HISTORIC AND DESIGN REVIEW COMMISSION

HDRC CASE NO: 2019-259
ADDRESS: 119 BUFORD
LEGAL DESCRIPTION: NCB 1369 BLK 6 LOT S 81.3 FT OF 4
ZONING: R-4, H
CITY COUNCIL DIST.: 2
DISTRICT: Dignowity Hill Historic District
APPLICANT: Mark Granato/Granato Custom Homes
OWNER: Mark Granato/DAL HOLDINGS LLC
TYPE OF WORK: Construction of a 1 story, single family residential structure
APPLICATION RECEIVED: April 30, 2019
60-DAY REVIEW: June 29, 2019
CASE MANAGER: Edward Hall
REQUEST:

The applicant is requesting a Certificate of Appropriateness for approval to construct a one story, single family residential structure on the vacant lot at 119 Buford, located within the Dignowity Hill Historic District.

Site Plan

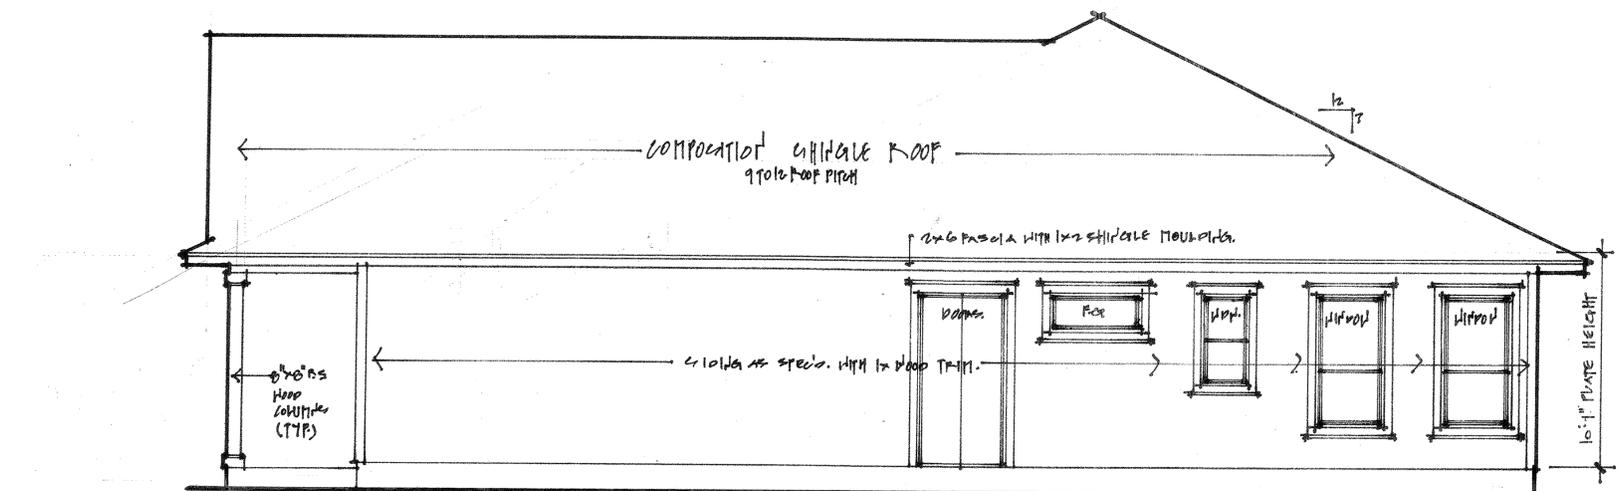
- vi. That a landscaping plan be submitted.
- c. SETBACKS & ORIENTATION – According to the Guidelines for New Construction, the front facades of new buildings are to align with front facades of adjacent buildings where a consistent setback has been established along the street frontage. Additionally, the orientation of new construction should be consistent with the historic example found on the block. Per the application documents, the applicant has proposed a setback of seven (7) feet front the front property line. Historic structures on this block feature setbacks that range in depth from approximately nine (9) to approximately fifteen (15) feet, when measured from the edge of the street paving. The applicant should propose a setback that is greater than the neighboring structures as well as those found on the north side of Buford Alley. To ensure that the proposed new construction is not built forward of the existing structures, staff finds that a site plan that includes the setbacks of adjacent structures should be submitted.

- l. DRIVEWAY – The applicant has proposed a ribbon strip driveway to be located on the west side of the proposed new construction. Staff finds the proposed profile and location of the driveway to be appropriate and consistent with the Guidelines. Staff finds that the driveway should not feature more than ten (10) feet in width.

- m. SIDEWALK – The applicant has proposed a front sidewalk consisting of decomposed granite. The Guidelines for Site Elements 5.A.iii. notes that the alignment, configuration and width of sidewalks should be followed when installing new sidewalks and walkways within historic districts. The historic pattern in the Dignowity Hill Historic District is for a concrete front sidewalk feature approximately three (3) feet in width. Staff finds that the applicant should adhere to the historic pattern found within the district.

- i. That the applicant confirm that the proposed setback is greater than those of the neighboring historic structures.
- ii. That the applicant incorporate additional fenestration on the east façade.

- v. That all mechanical equipment be screened from view from the public right of way.
- vi. That the proposed ribbon strip driveway not exceed ten (10) feet in width.

- vii. That the proposed front sidewalk be concrete and feature a width of approximately three feet to match those found historically on the block.
- viii. That the applicant submit a detailed landscaping plan to staff for review and approval.

Right Side Elevation SCALE: 1/4" = 1'-0"

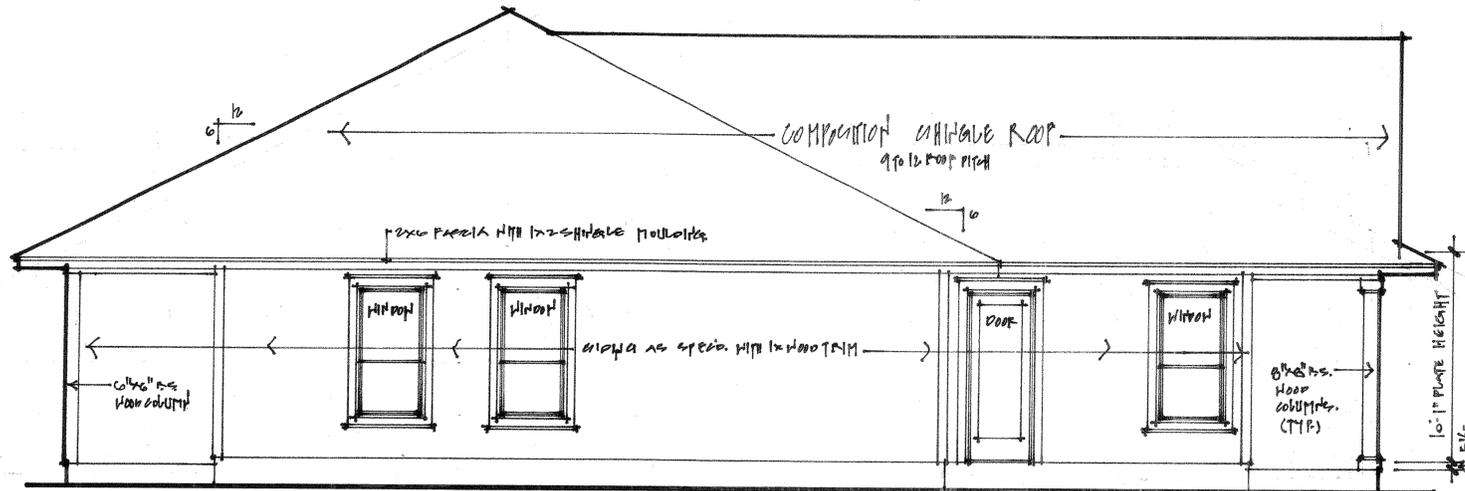
- h. ARCHITECTURAL DETAILS – The applicant has proposed an overall form and massing that are comparable to that found on Buford Alley and predominantly throughout the Dignowity Hill Historic District. Staff finds that additional fenestration along the east facade, particularly in the living room and on the west façade in the dining area should be added to separate wall planes that are currently blank.

Front Elevation SCALE: 1/4" = 1'-0"

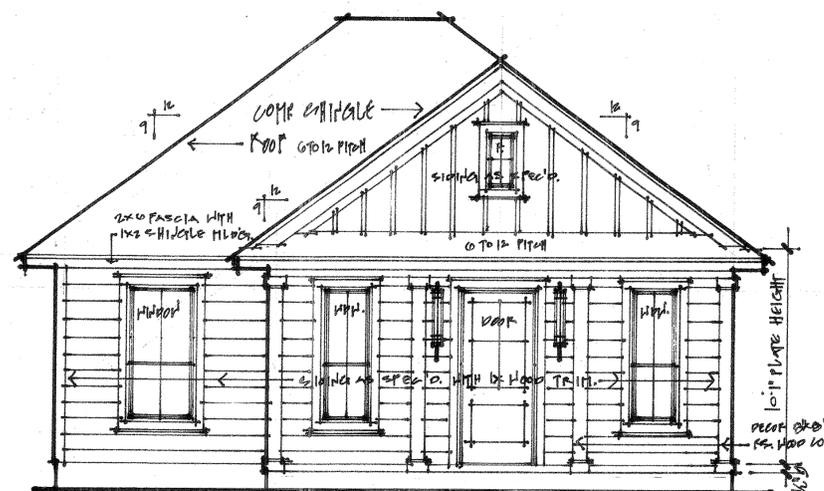
- f. FOUNDATION & FLOOR HEIGHTS – According to the Guidelines for New Construction 2.A.iii., foundation and floor height should be aligned within one (1) foot of neighboring structure’s foundation and floor heights. The applicant has increased the proposed foundation height since conceptual approval to feature a height twelve to eighteen inches. Generally, this is consistent with the Guidelines.

- g. ROOF FORM – The applicant has proposed for the new construction to feature both a front facing, gabled porch roof and a primary roof structure that is a hipped roof. Generally, the proposed roof form is appropriate.
